SUBJECT: ISSUANCE OF AMENDMENTS FOR DIABLO CANYON NUCLEAR POWER PLANT,
UNIT NO. 1 (TAC NO. M95908) AND UNIT NO. 2 (TAC NO. M95909)

SUBJECT: ISSUANCE OF AMENDMENTS FOR DIABLO CANYON NUCLEAR POWER PLANT,
UNIT NO. 1 (TAC NO. M95908) AND UNIT NO. 2 (TAC NO. M95909)

Amendment No. 116
License No. DPR-80

Amendment No. 114
License No. DPR-82

FIGURE 3.9-2
 MINIMUM REQUIRED ASSEMBLY DISCHARGE BURNUP
 AS A FUNCTION OF INITIAL ENRICHMENT AND PELLETT DIAMETER TO PERMIT
 STORAGE IN REGION 2

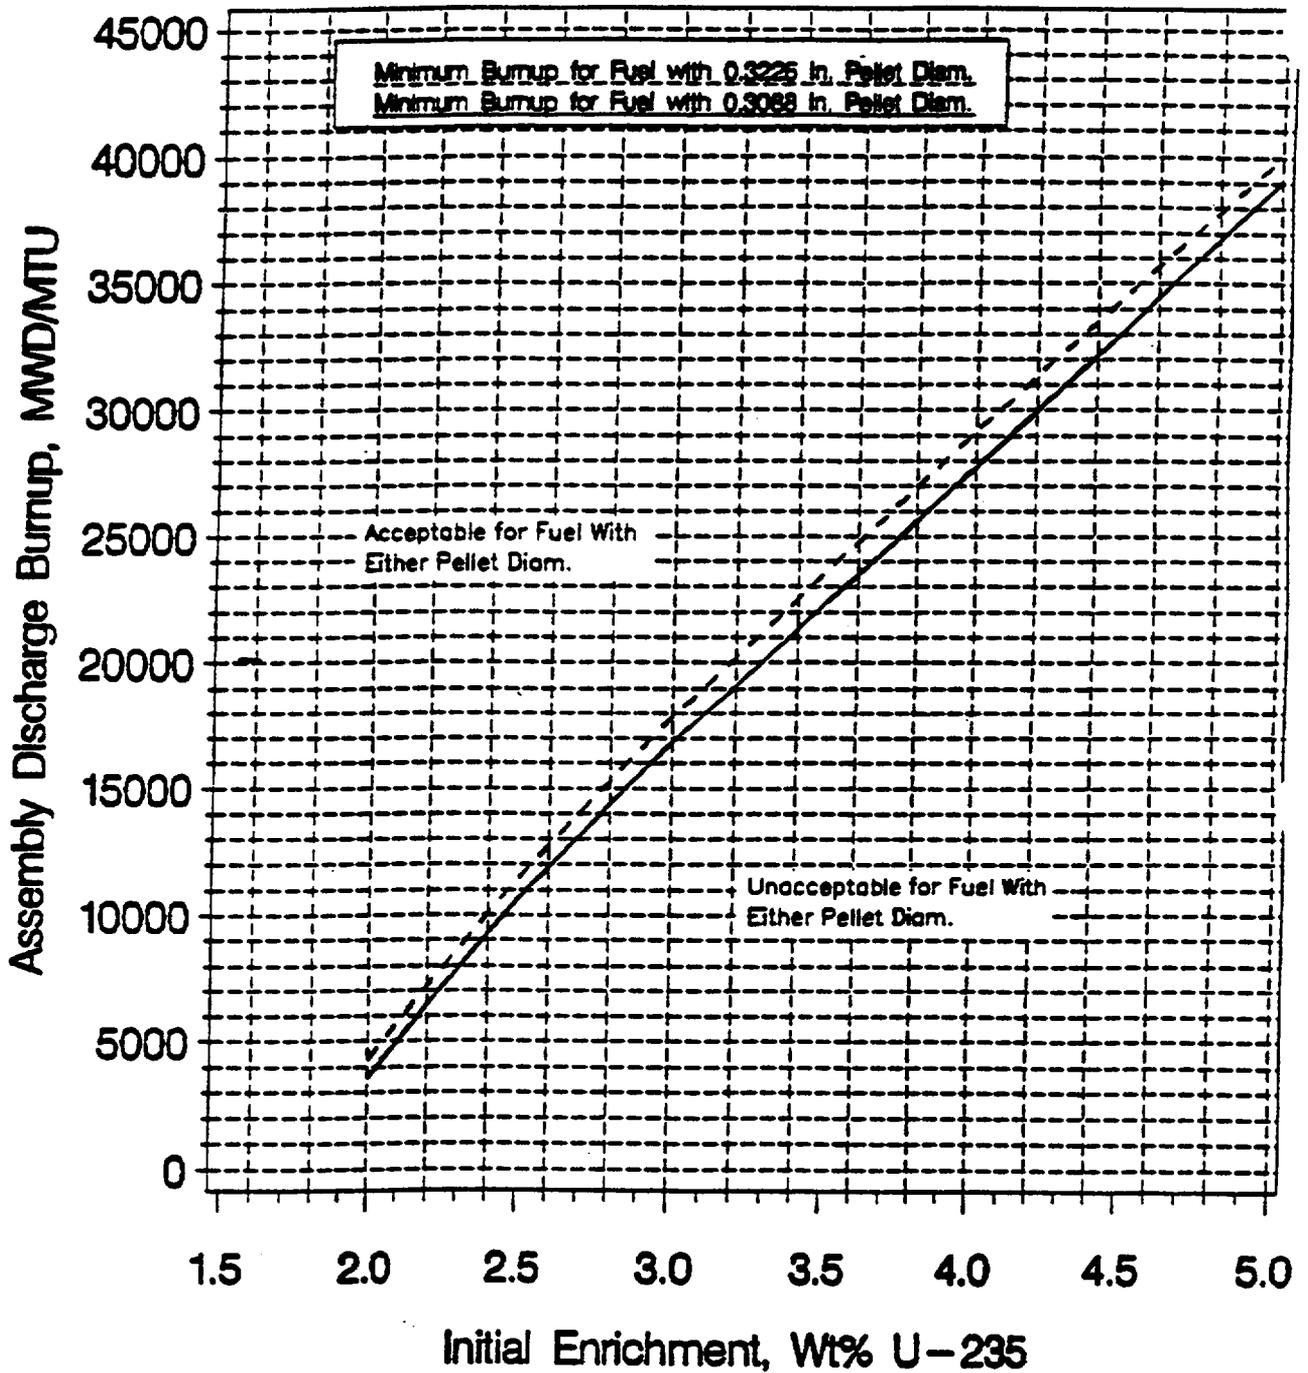
- a. The combination of initial enrichment, fuel pellet diameter, and cumulative burnup of the assemblies is within the acceptable area of Figure 3.9-2; or
- b. The assemblies are put into a checkerboard pattern with water cells or non-fissile material.
